March 26, 2010
File: 02-0775-50-3896/Vol 01

Re: Addendum #2 3896Q Supply and Installation of Ice-Rink Dasherboard System

DWG NAME: Rink 1 : Dasherboard Layout		
DWN BY:	SCALE:	
PROJECT: Richmond Oval Arena		
REV.:	DATE: 22MARCH2010	DWG No: 2 OF 7

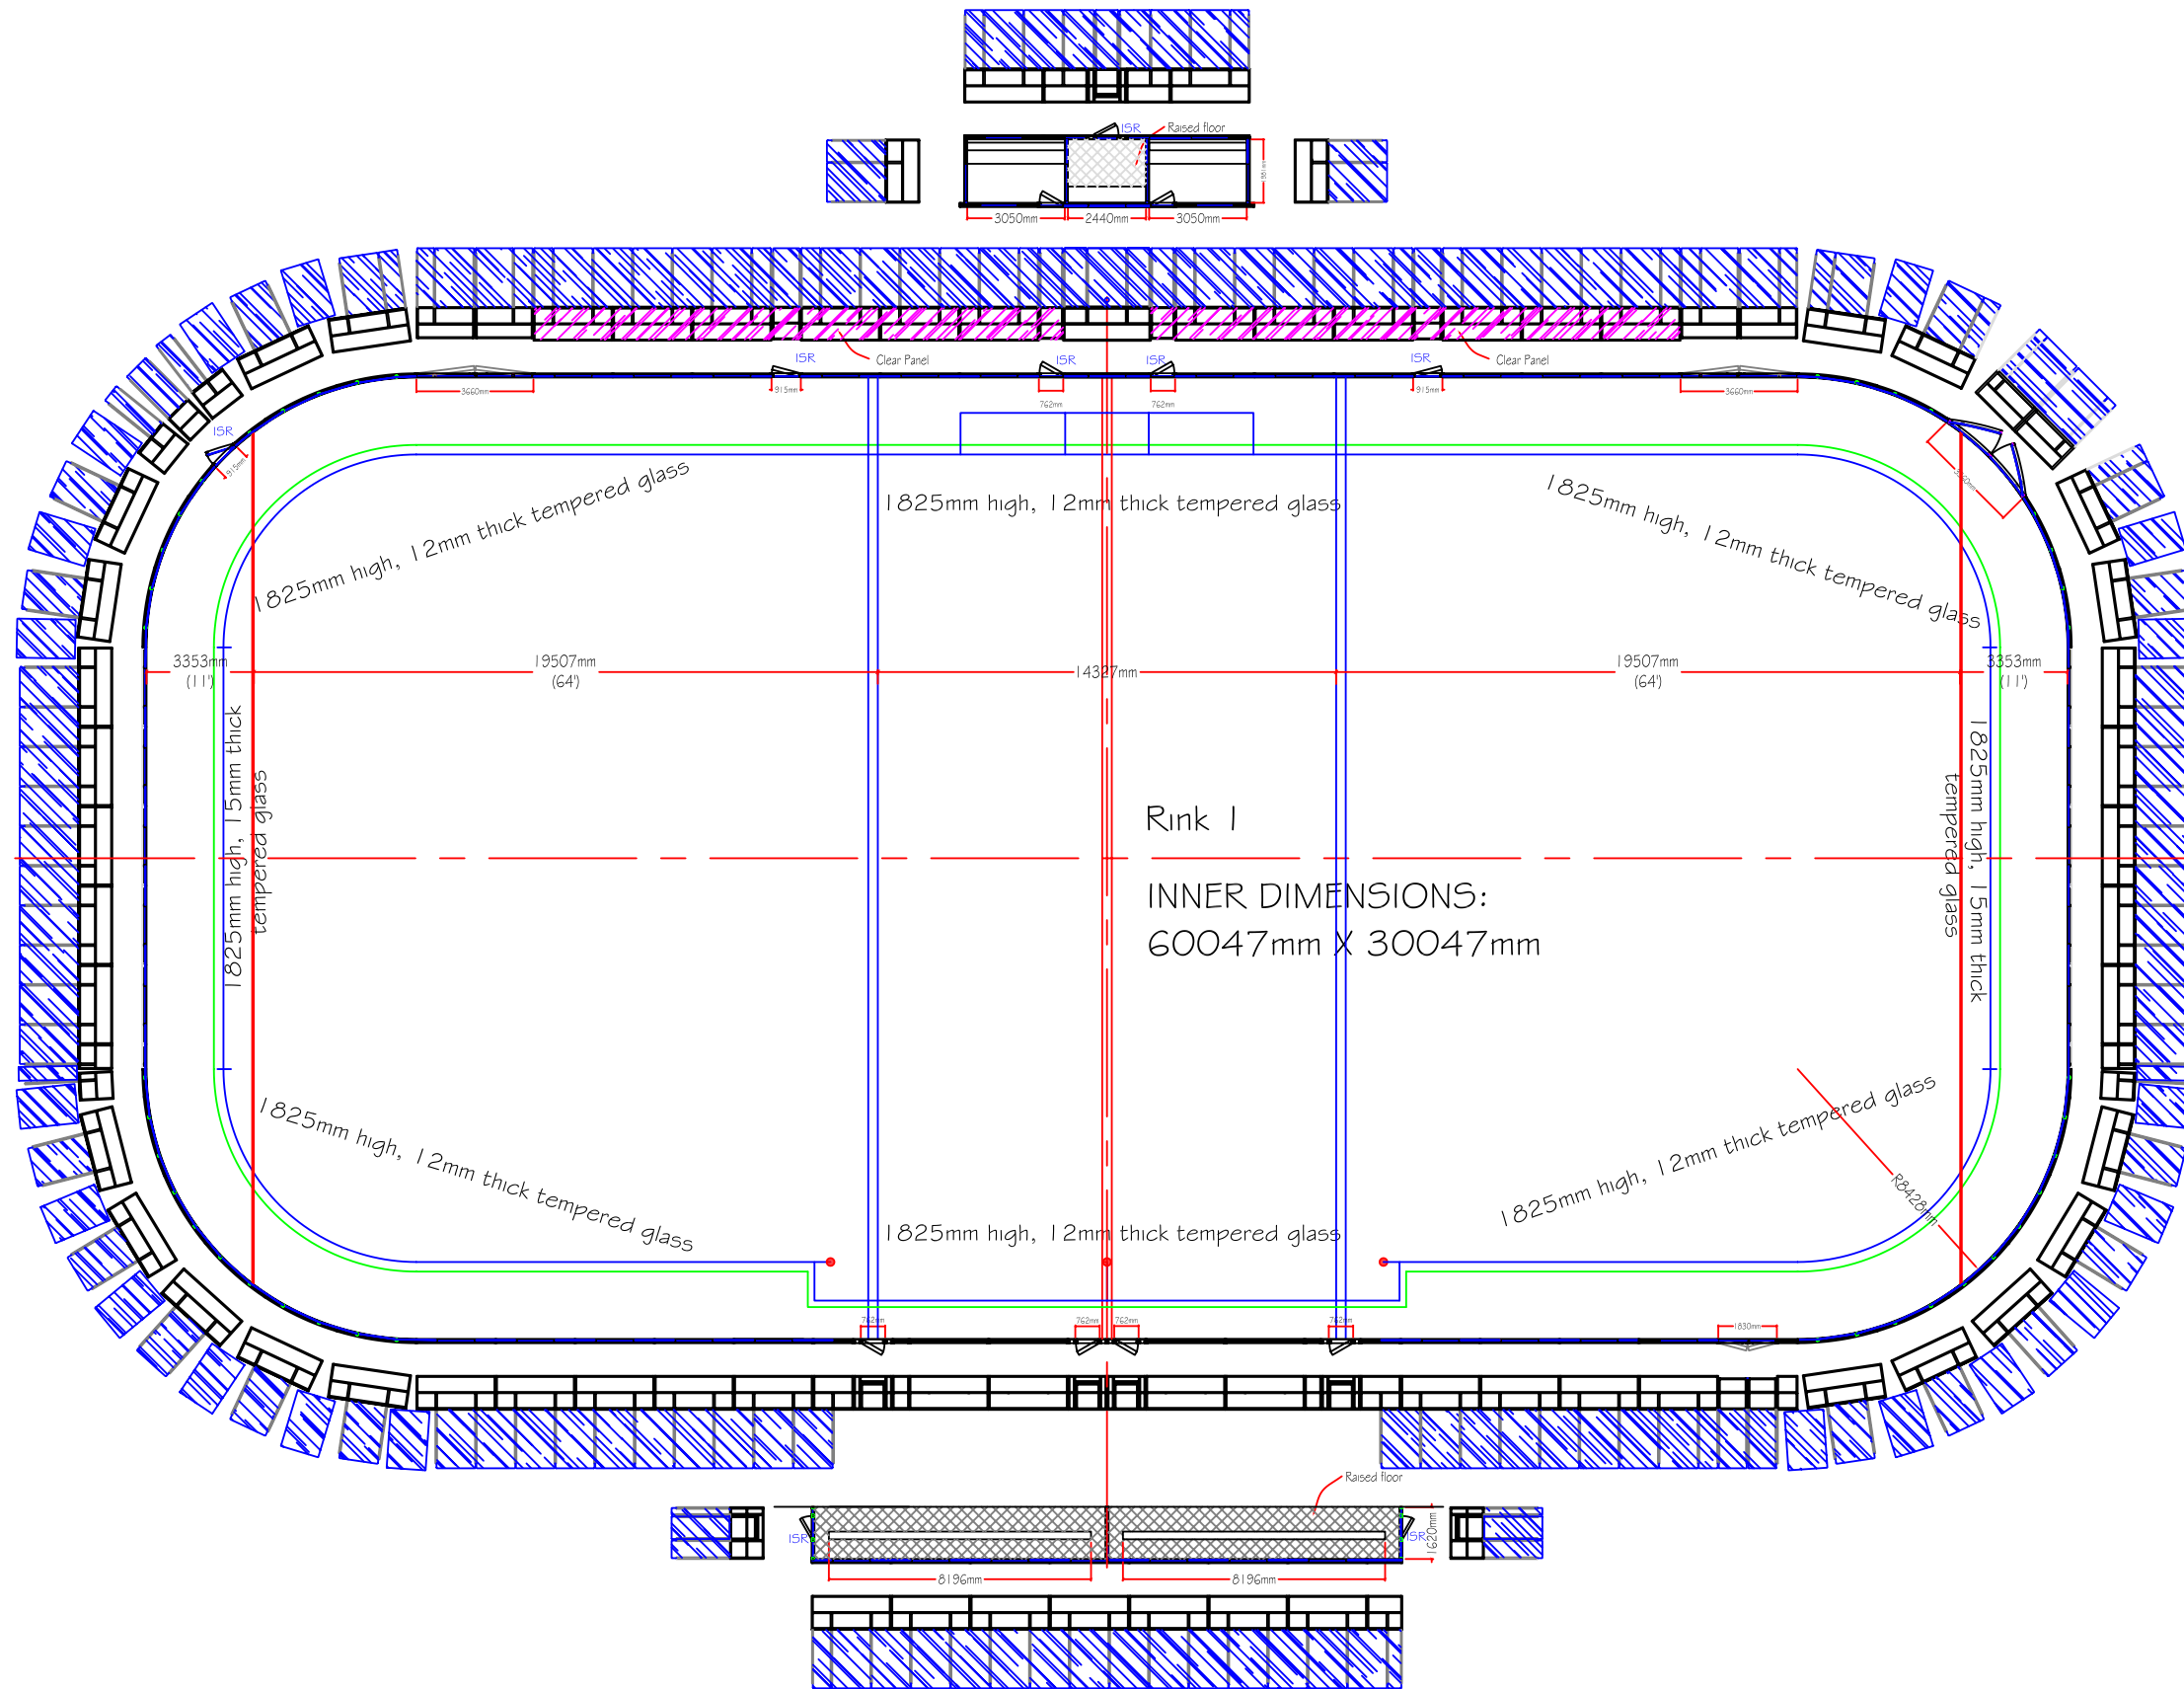
6. You show a double public access gate on only one rink and there is no size noted. We would suggest it be a double gate that is 1828mm wide.
7. There are two players access gates shown, they are drawn as double gates and without measurements. We would suggest 912mm wide single access gates.

9. None of your drawings show the access gates into the sledge hockey players boxes.
10. None of your drawings show the extent of the 12mm clear polycarbonate panels

Answer: Please see the attached drawings.

DWG NAME: PENALTY BOX SECTION		
DWN BY:		SCALE: N.T.S
PROJECT: Richmond Oval Arena		
REV.:	DATE: 22MARCH10	DWG No: 5 of 7

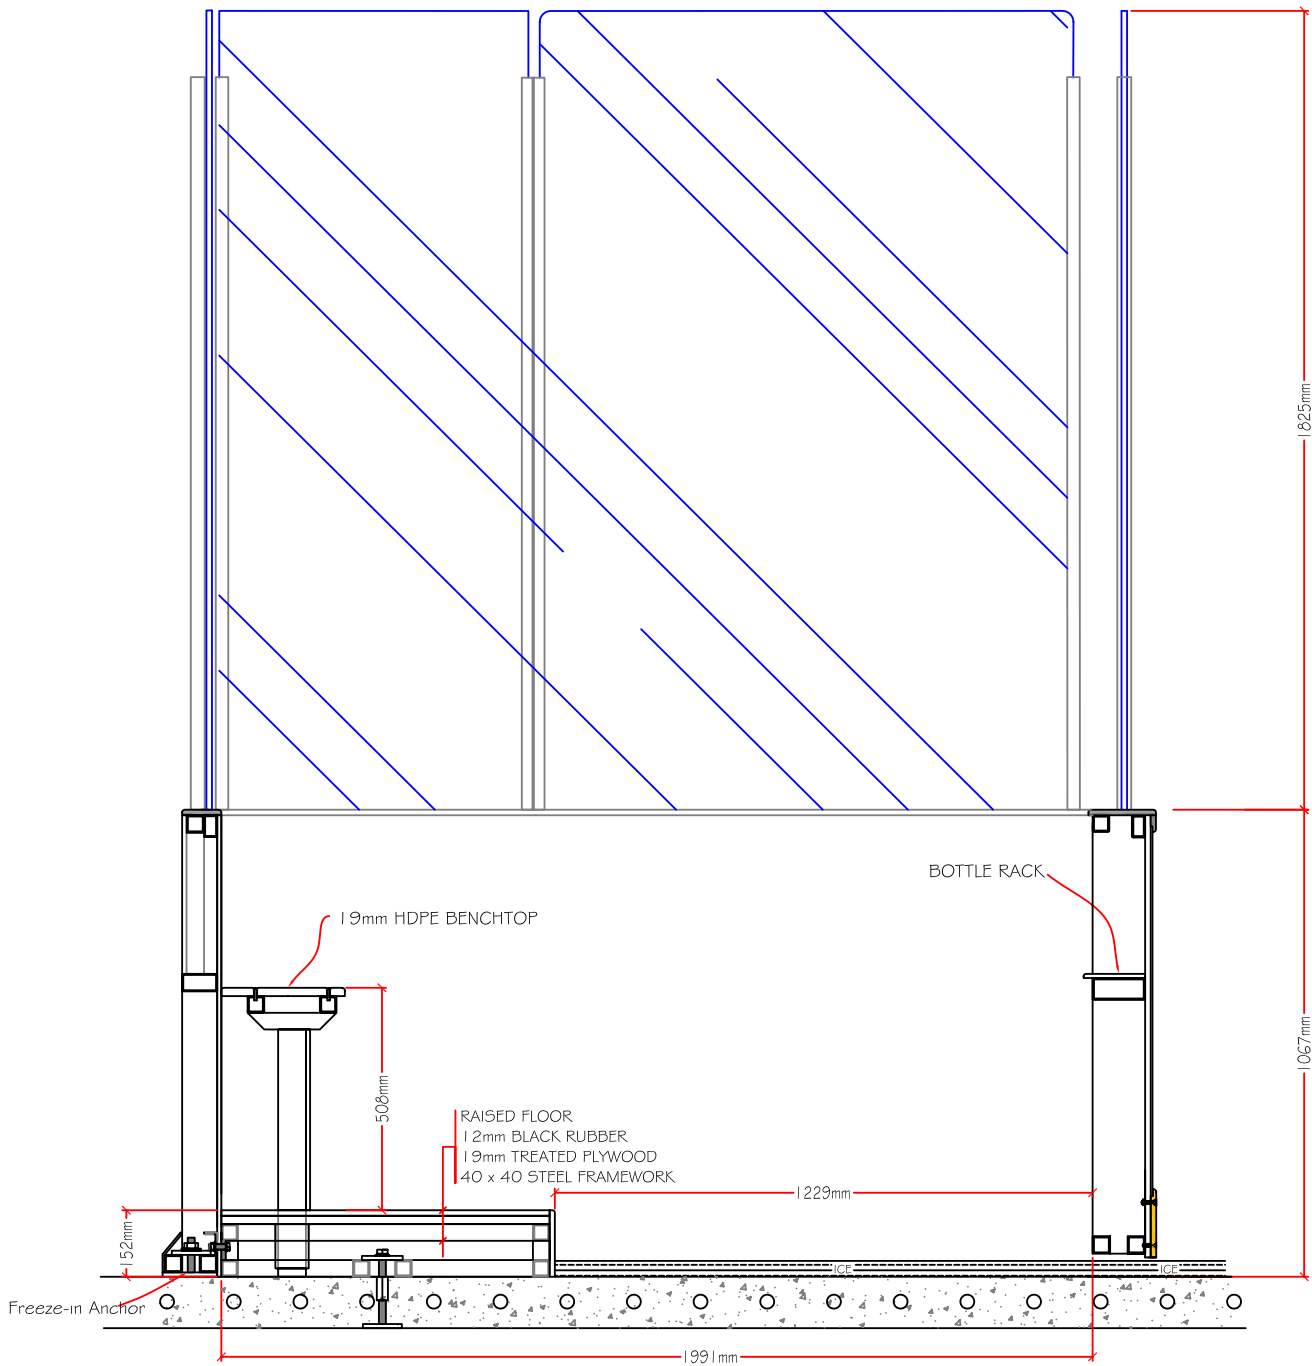
8. On the "Dasher Board Plan" the depths of the combination penalty boxes are shown at 1500mm this is typical to a standard able bodied penalty box but since you want to have a combined use of this box and you would probably want to have raised area in the back of the box to allow the able bodied players and off ice officials to get off the ice surface. We had talked about making these boxes slightly deeper to 1620mm (inside to inside on the box)

DWG NAME: GATE SECTIONS		
DWN BY:	SCALE: N.T.S.	
PROJECT: Richmond Oval Arena		
REV.: -	DATE: 22MARCH10	DWG No: 7 OF 7

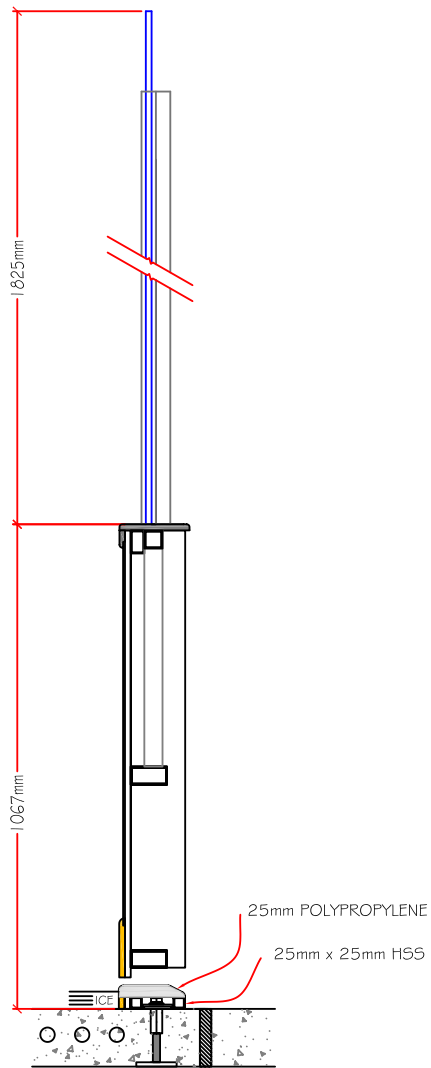
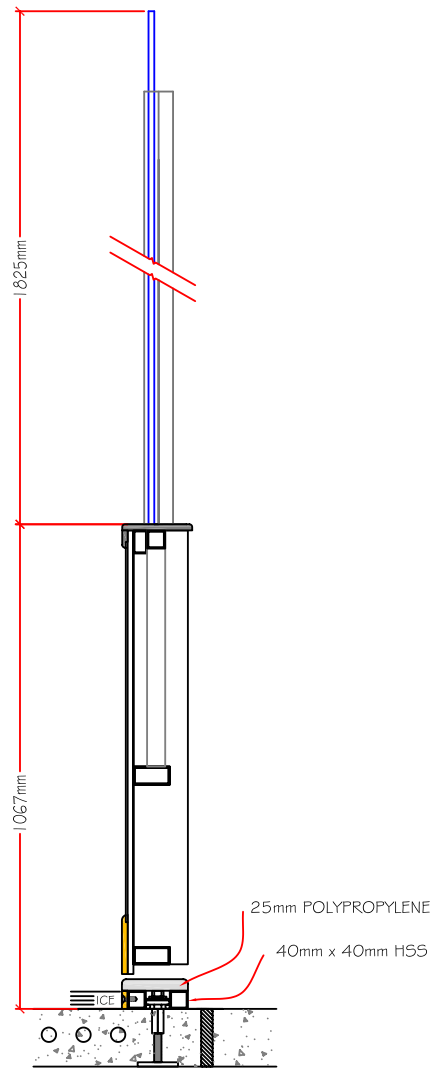
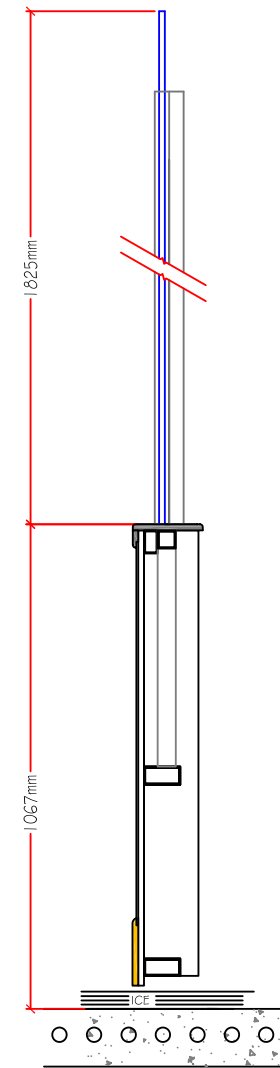
3. On gates sizes it reads players gates are to be 762mm I would suggest adding a note that all gates for sledge hockey players and penalty boxes should be 914mm. The hand drawn layout needs some clarification.

4. It notes “movable section or gates” for the large 12’ opening to pass from one rink to the next. A movable section is much less functional and also less expensive to build so I am concerned some of the other bidders may choose this option to reduce their bid cost.

5. The access gate for the speed skating pads is noted at 1.5m. Do you want this in a single gate or as a double gate. We would suggest a single gate would work fine.

Answer: Please add the following, Page 17 Part 2 - Products: 2.3.E.2 All gates for Sledge Hockey Player’s and penalty boxes shall be 914 mm.

Answer: These shall be gates and not movable sections.

Answer: Single gate will be fine at 914 mm.
